WILLIAMSON COUNTY, TEXAS

CHANGE ORDER NUMBER: 6

**Forest North Drainage Phase 3
Williamson County Project No. 3866**

Change Order No. 6

SCALE
DATE: 7/24/2020
SHEET NO. SB7 OF SB10
SHEET 120 OF 201

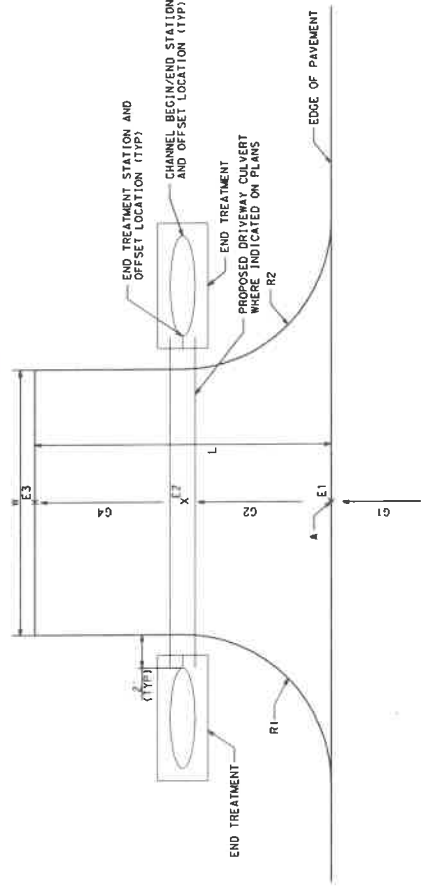
1A: Design Error or Omission. Incorrect PS&E. This Change Order adds an item to pay for 24" RCP 6:1 safety end treatments (SET's). Plan sheet 120 of 201 (SB7 of SB10) calls for the 24" RCP on Chester Forest Street to have 6:1 SET's but no pay items were created to pay for this item on the bid forms.

This Change Order adds a new item to pay the Contractor for 24" Reinforced Concrete Pipe (RCP) 6:1 Safety End Treatments (SET). The plans call to install 6:1 SET's on the 24" RCP at the ends of driveway culverts on Chester Forest in the Sherbourne Zone. On the bid form, no pay item was set up for this work. Item 0467-6392 (SET (TY II) (24IN) (RCP) (6:1) (P)) is added to pay for this work.

ITEM	DESCRIPTION	QUANTITY	UNIT
0467-6392	SET (TY II) (24IN) (RCP) (6:1) (P)	6	EA
